CUYAMA BASIN GROUNDWATER SUSTAINABILITY AGENCY STANDING ADVISORY COMMITTEE

AGENDA

November 29, 2018

Groundwater Sustainability Plan Update

Figure 2.2-11: Cuyama GW Basin Hydrographs

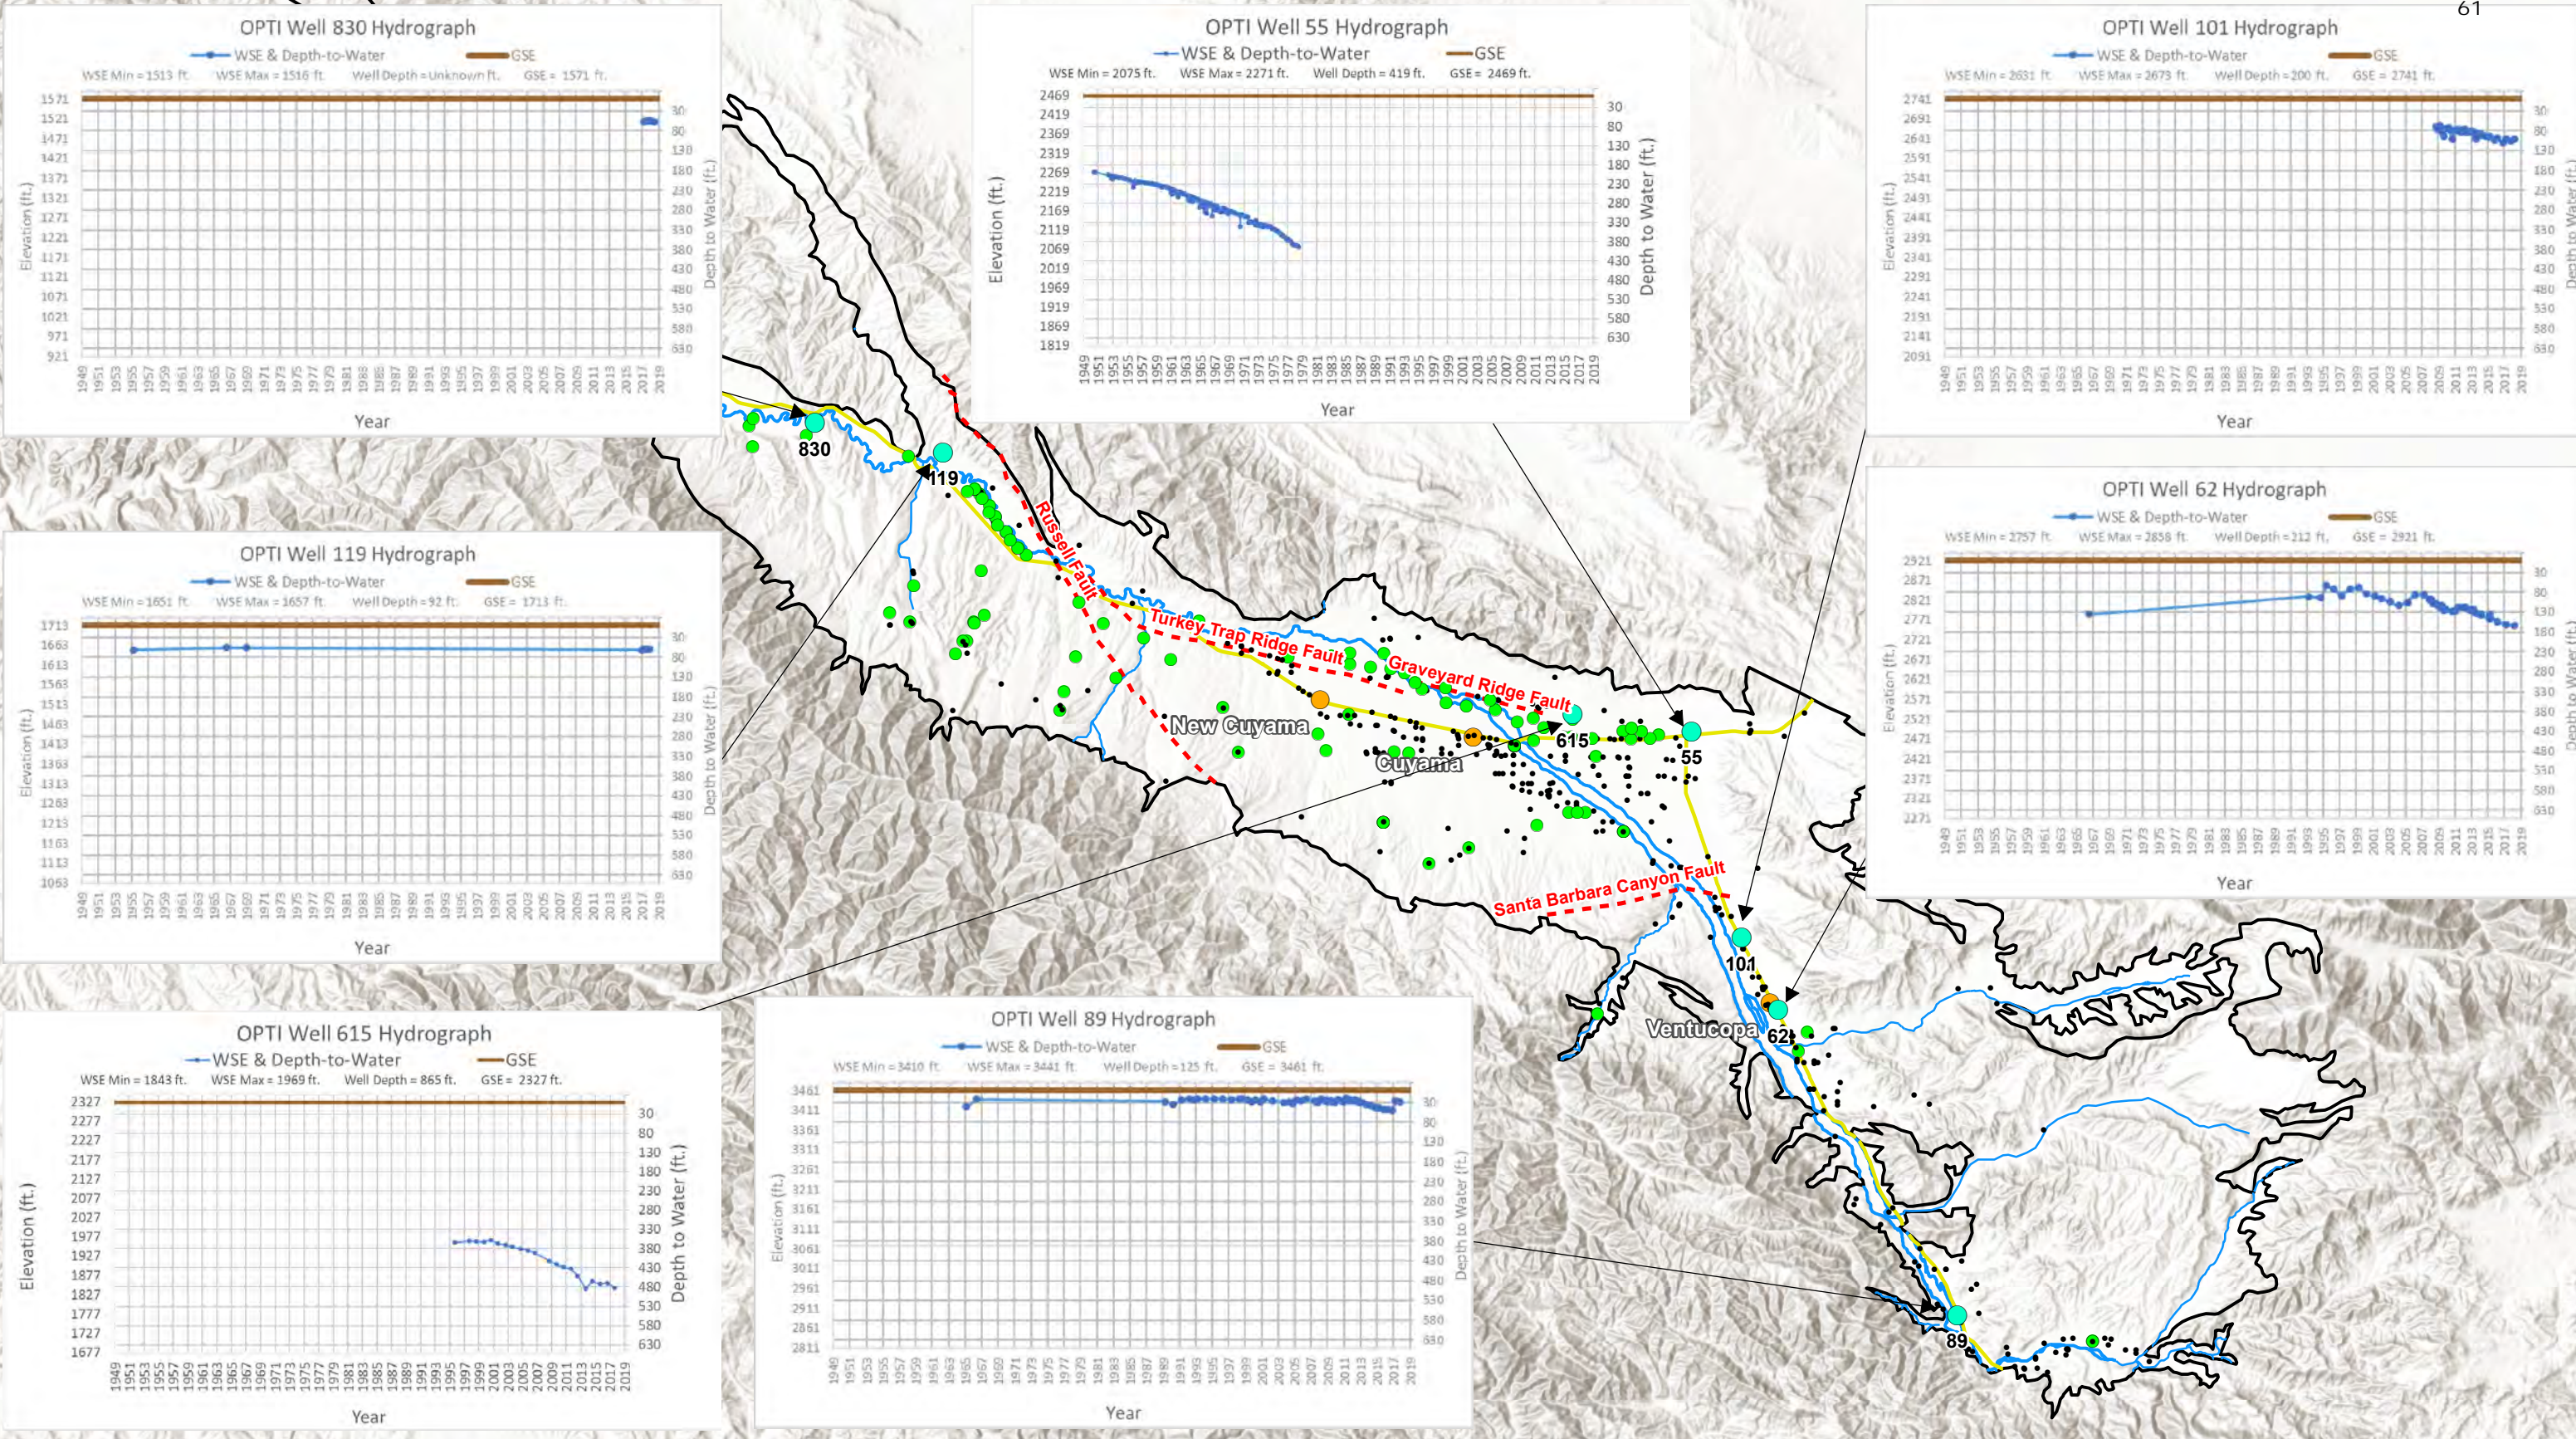
143	Matt Young, Matt Scudato, & Fray Crease	Santa Barbara County Water Agency	2.2.3 GW Hydrographs			Figure 2.2-11 shows Hydrographs in different portions	Please describe in the text why these wells were chosen. Are they representative of the areas?	The text and figure have been revised for clarity.
144	Matt Young, Matt Scudato, & Fray Crease	Santa Barbara County Water Agency	2.2.3 GW Hydrographs	Bullet list		In the area southeast of Round Springs Canyon	Please edit for clarity and grammar. Also, if you are going to describe the hydrographs, you should describe all of them If they want to generalize then make the graph mimic these areas, pick 5 representative hydrographs. Right now there are 7 on the Figure which looks cluttered.	The text has been revised for clarity.
145	Matt Young, Matt Scudato, & Fray Crease	Santa Barbara County Water Agency	Figure 2.2-11				Bitter Creek area - illustrate on map as a reference	This is labeled on Figure 2.2-1

Figure 2.2-20: Cuyama GW Basin Wells by Depth to Water
 Cuyama Basin Groundwater Sustainability Agency
 Cuyama Valley Groundwater Basin Groundwater Sustainability Plan
 August 2018

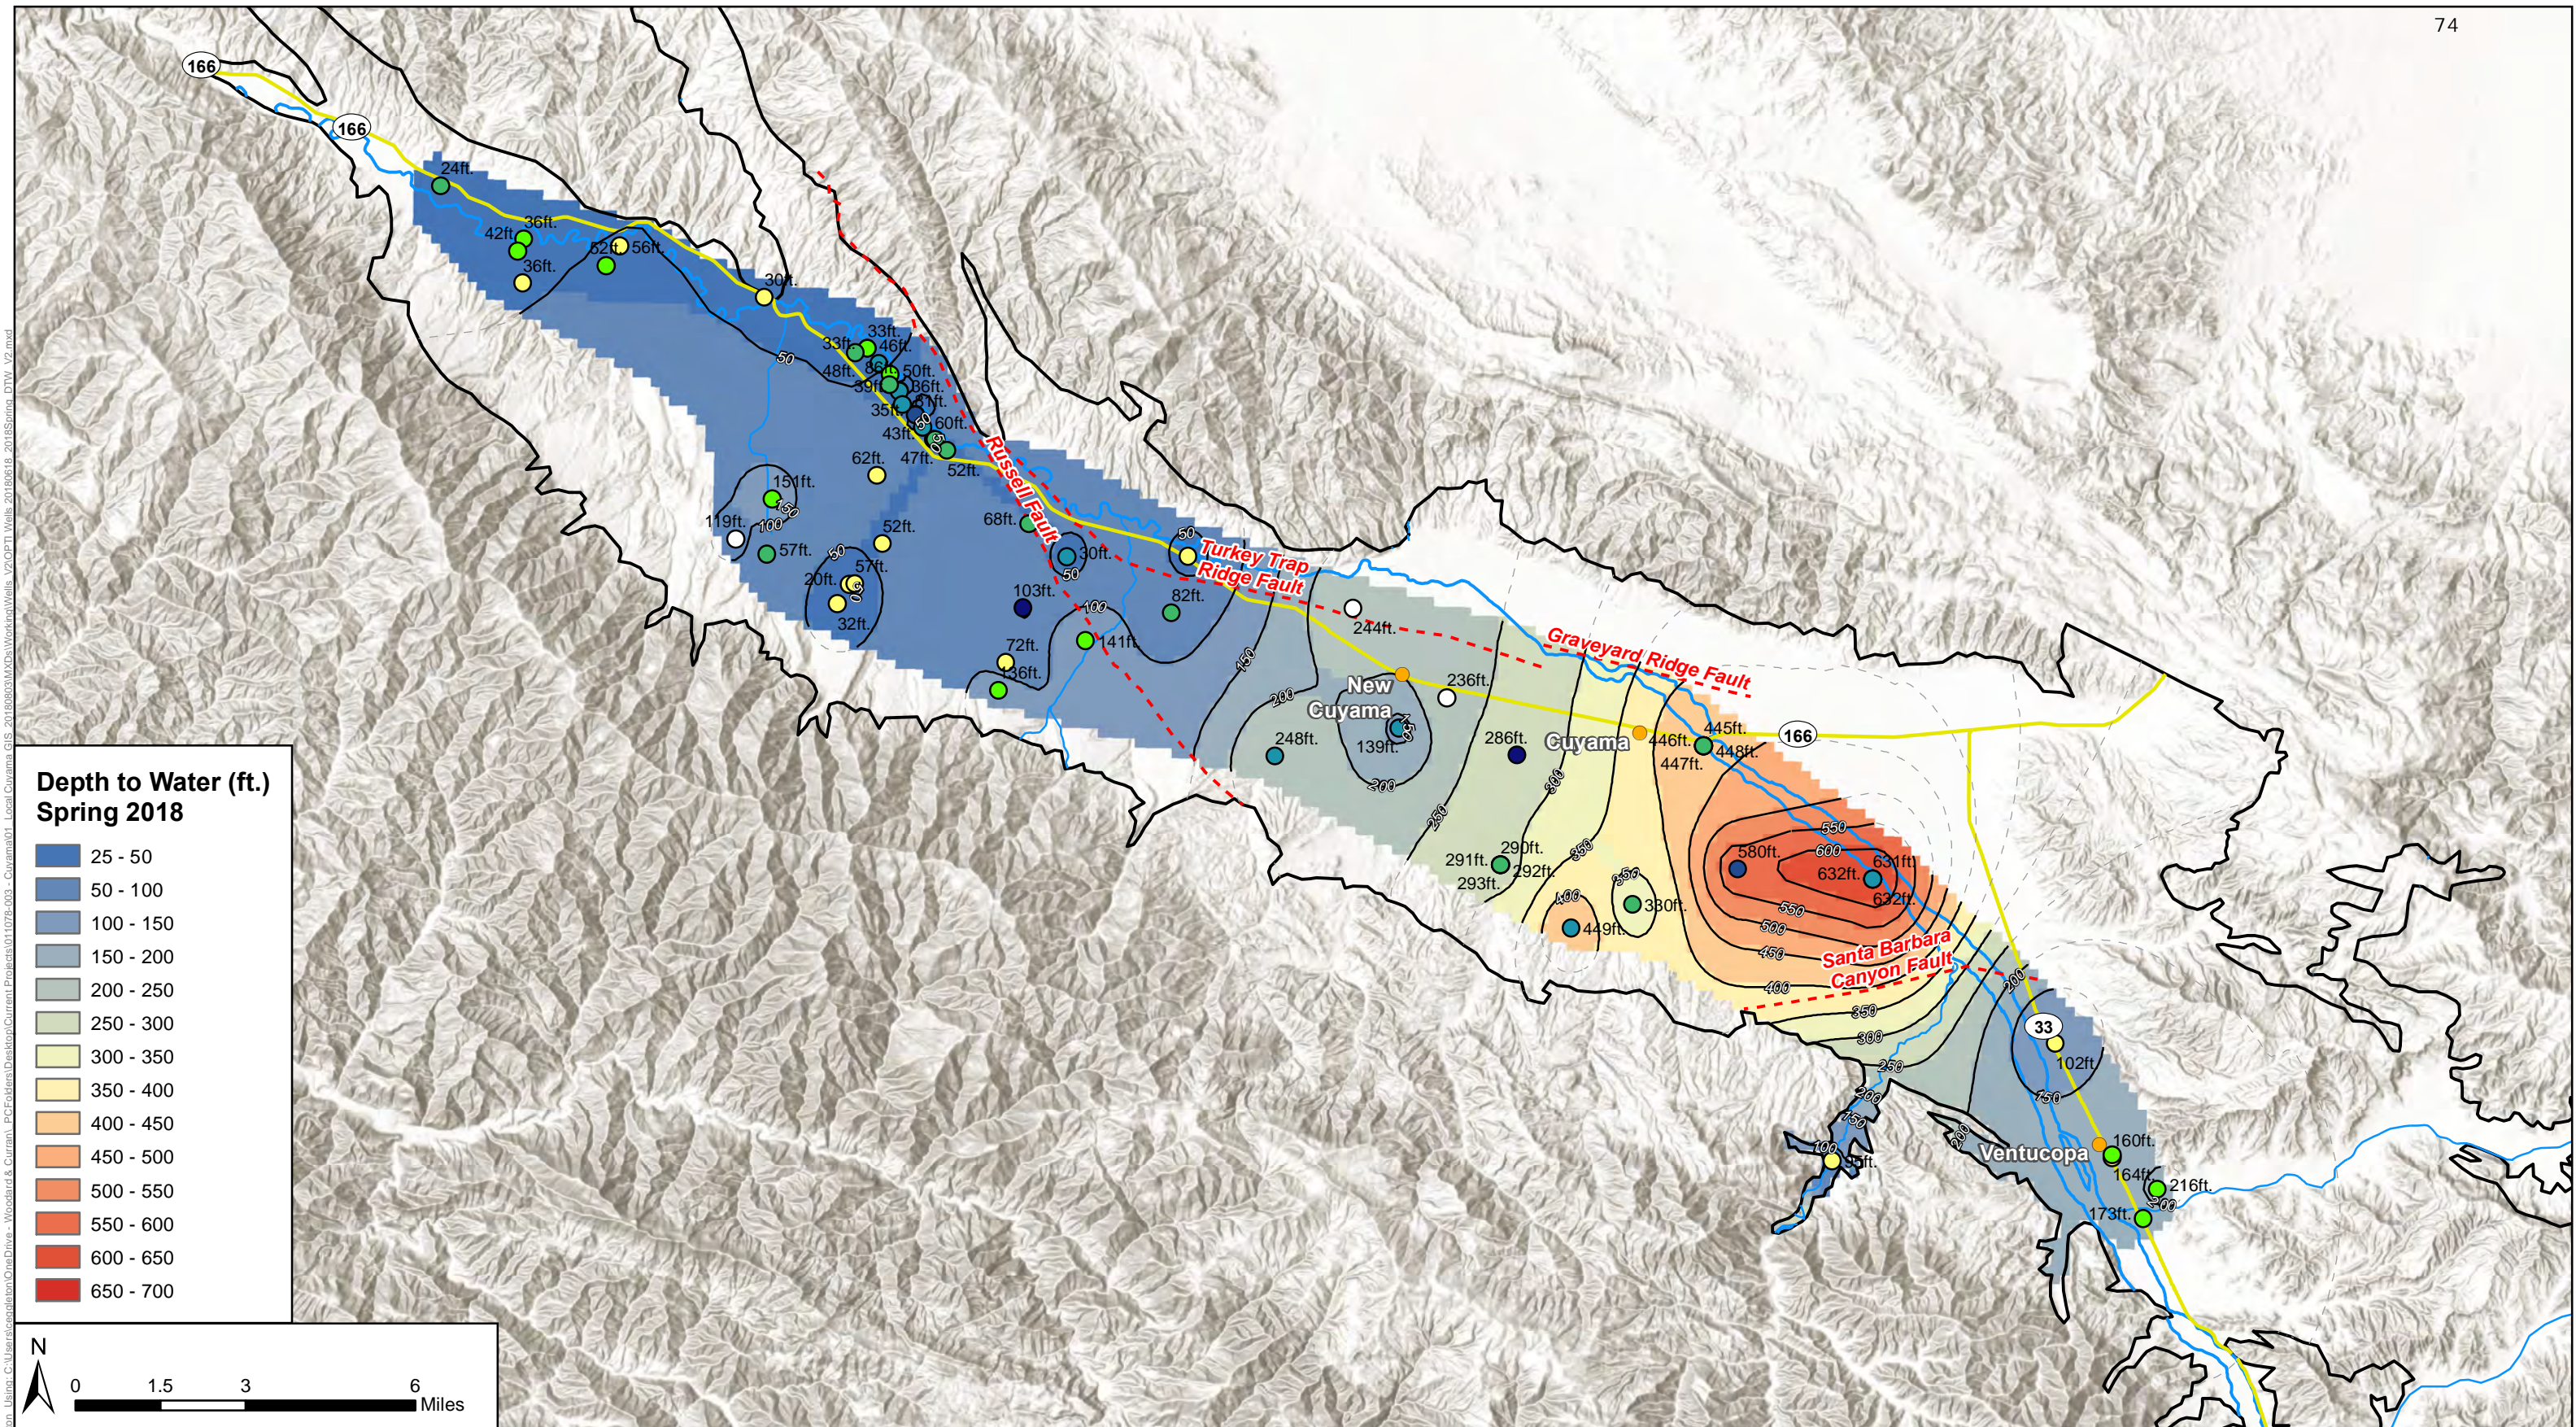
8	Brenton Kelly	Quail Springs Permaculture	2.2.3	N/A	N/A	Fig. 2.2-20	Illustrates a classic example of a Bullseye depression. Speak to the significance of these conditions. Speak also to the Data Gaps representing the missing northeast area, near the intersections of 166 & 33. How big or deep is the zone of depression?	Comment noted. The document notes that the depth to water is up to 600 feet deep.
9	Brenton Kelly	Quail Springs Permaculture	2.2.4	1	N/A	Bullet #1	Storage loss is a significant groundwater condition that should be measurable, but we are going to model it first. The cart is before the horse!	While changes in groundwater storage can be inferred from changes in groundwater levels, storage quantities cannot be directly measured with the available data. The numerical model will provide the best available estimate of groundwater storage.
10	Brenton Kelly	Quail Springs Permaculture	2.2.6	2	1	Subsidence	Subsidence at a rate of > 0.5" / year should not be dismissed or diminished by comparison to the collapse of the San Joaquin. This is a critical Data Gap with only one monitor site in the central basin. It may or may not be anomalous without anything to compare it to	Comment noted. The need for additional subsidence monitoring is discussed in the Monitoring Networks section.
